# MODIFICATION OF CONSENT REPORT - 008/11DA(S96037/14) – PROPOSAL FOR TWO ADDITIONAL REFRESHMENT ROOMS, LOT 1 DP 1171714 CAROLINE AVENUE LITHGOW NSW 2790

## 1. PROPOSAL

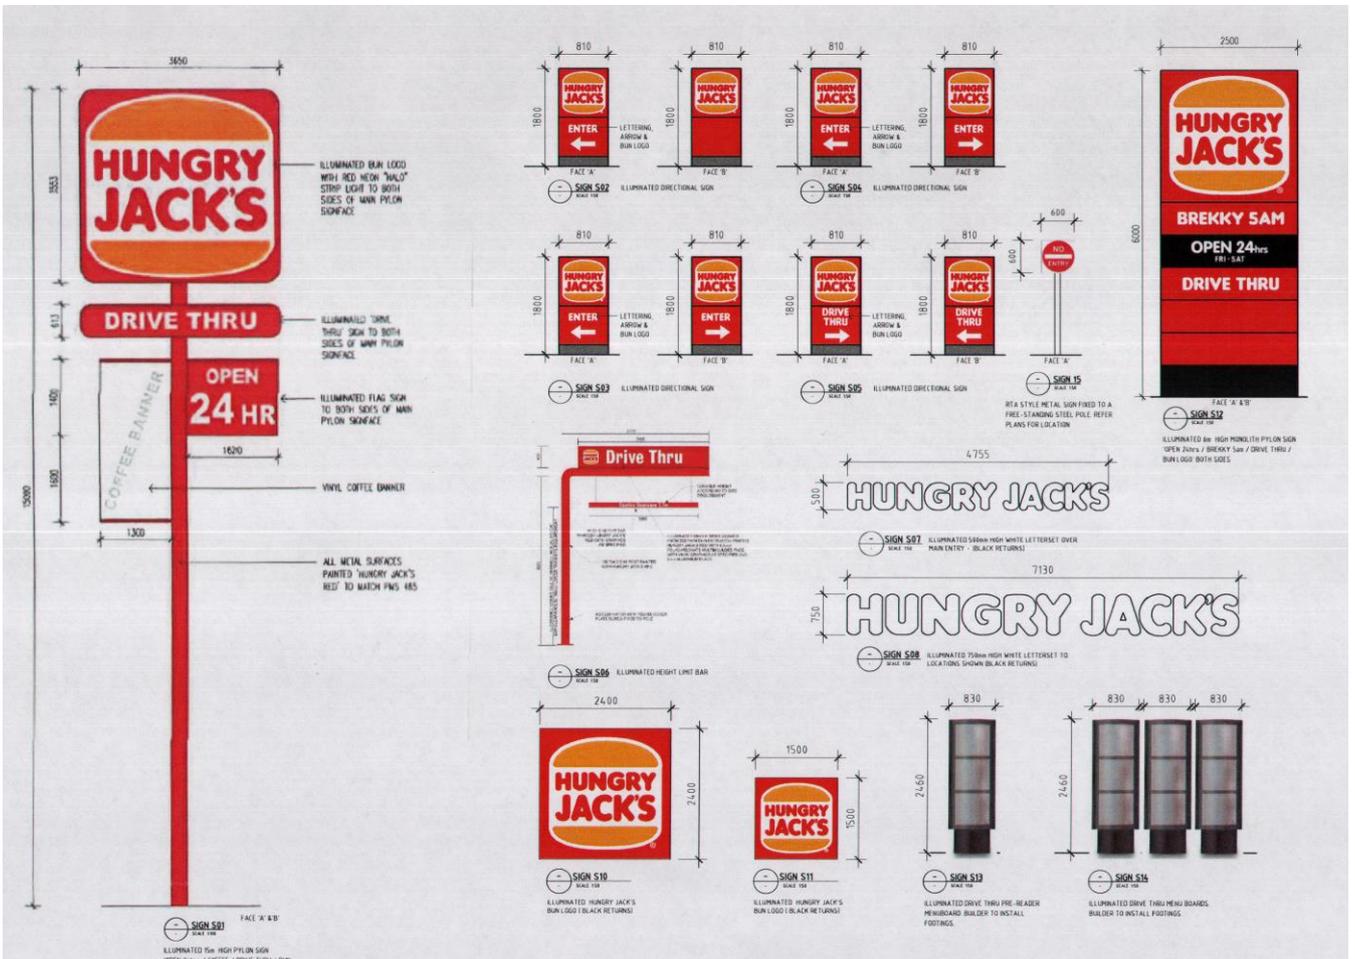
Council is currently in receipt of a modification of consent application from Andrew McIntosh from Martin, Morris & Jones Pty Ltd seeking to add two refreshment room tenancies, change the site layout and the floor plans as shown:

Additionally it is requested that conditions of consent be modified to clarify that carrying out of survey work will not require a Construction Certificate or notification to Council of existing damage to property controlled by Council for conditions 4 and 75. Further, the applicant requests that the individual applications for the use of the two new tenancies will be subject to separate Development Applications.
